Serial No.: 10/695,018

REMARKS**Present Status of the Application**

Discussion of Drawings Objection

Annotated Marked-up drawing**FIG. 1A (PRIOR ART)****FIG. 1B (PRIOR ART)**

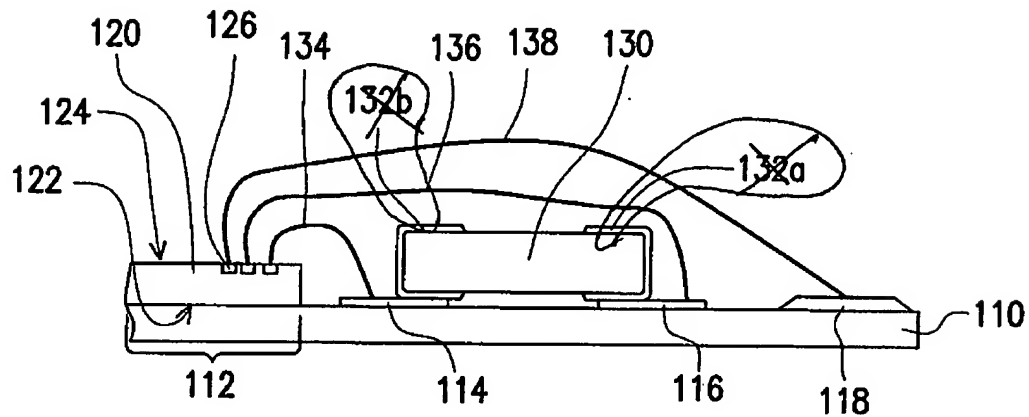
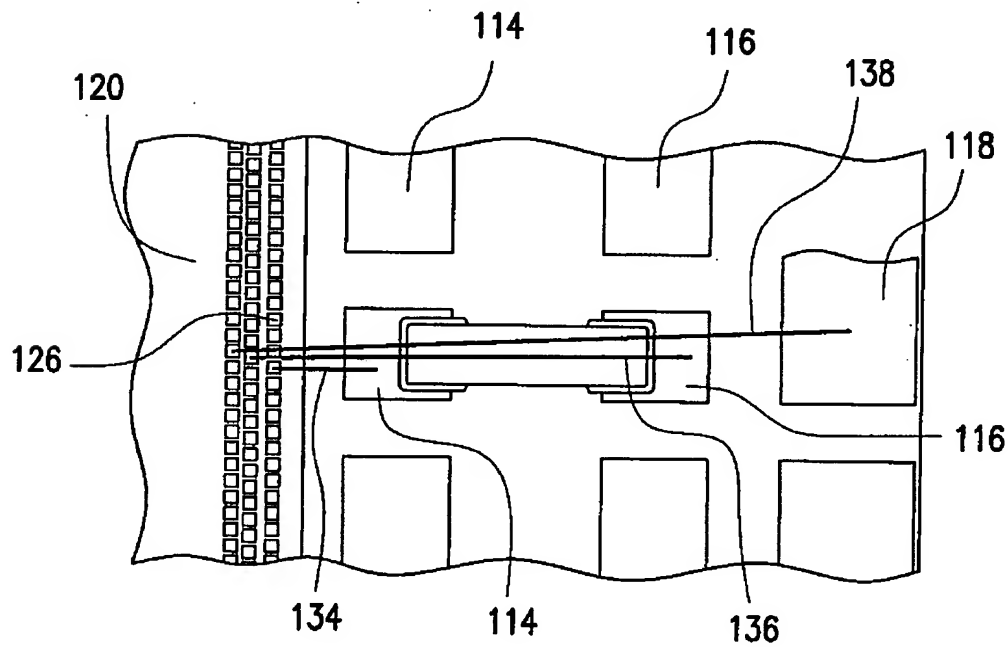
Figures 1B and 2B are objected to as failing to comply with 37 CFR 1.83(a) because they show inconsistent dispositional relationships between the passive component and the electrodes 132b and 232b and it is not clear whether the electrodes are at the top end of the passive element or at the sides thereof.

Please amend Figures 1A, 1B, 2A, and 2B according to the replacement drawings as attached herewith.

In response thereto, Applicants have amended Figures 1A, 1B, 2A, and 2B to clarify the dispositional relationships between the passive component and the electrodes 132b and 232b and to clarify that the electrodes are at the top end and bottom end of the passive element. Withdrawal of the objection is respectfully requested.
